Access Compliance Report

Public Rights-of-Way

(Curb Ramps)

Intersection ID: N/A	Main Street: WAVERLY_WALK_AV	Cross Street: HONEYMEADE_CIR	Location: SW
ADA ID: 711C96193C66	Ramp Type: Directional1	Initial Pass/Fail: Fail	Overall Compliance: No
		Severity Score: 12.5

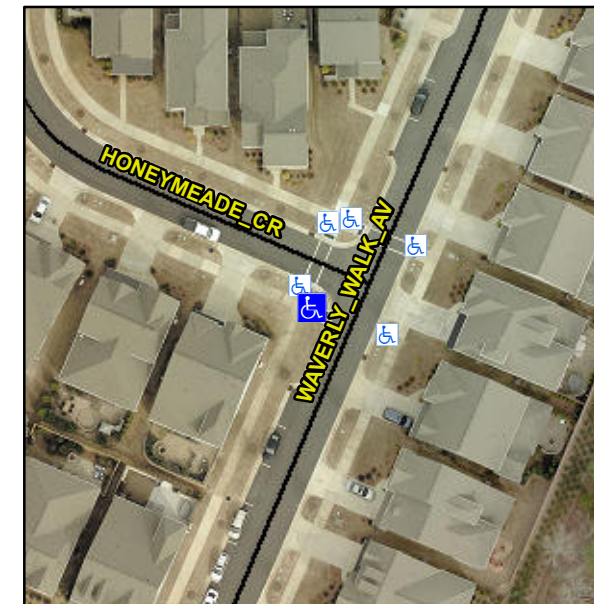
R304.2.2

Compliance	Description	Data	Compliance	Description	Data
N/A	Ramp Length (in)	157.0	N/A	Grade Break?	N/A
Yes	Ramp Width (in)	72.0	N/A	Grade Break Slope (%)	0.0
No	Ramp Slope (%)	8.4	N/A	Grade Break XSlope (%)	0.0
Yes	Ramp XSlope (%)	0.5			
N/A	Flare Type LT	N/A	N/A	Flare Type RT	N/A
N/A	Flare Slope LT (%)	N/A	N/A	Flare Slope RT (%)	0.0
N/A	Flare Traversable LT?	N/A	N/A	Flare Traversable RT?	N/A
N/A	Landing Length (in)	0.0	N/A	DWS Provided?	N/A
N/A	Landing Width (in)	0.0	N/A	DWS Contrast?	N/A
N/A	Landing Slope (%)	0.0	N/A	DWS Length (in)	N/A
N/A	Landing X Slope (%)	0.0	N/A	DWS Full Width?	N/A
N/A	Landing Curb? (Y/N)	N/A	N/A	DWS Offset LT (in)	N/A
N/A	Shared Landing?	N/A	N/A	DWS Offset RT (in)	N/A
N/A	Gutter Ponding?	0.0	N/A	Gutter Slope (%)	N/A
N/A	Gutter Lip Ht (in)	0.0	N/A	Gutter X Slope (%)	N/A
N/A	Painted X Walk1?	No		Road Slope (%)	0.7
	X Walk 1 Direction	To SE		Road X Slope (%)	0.4
	X Walk 1 Width (in)	N/A		Clear Space?	N/A

Remove & Replace Entire Ramp.
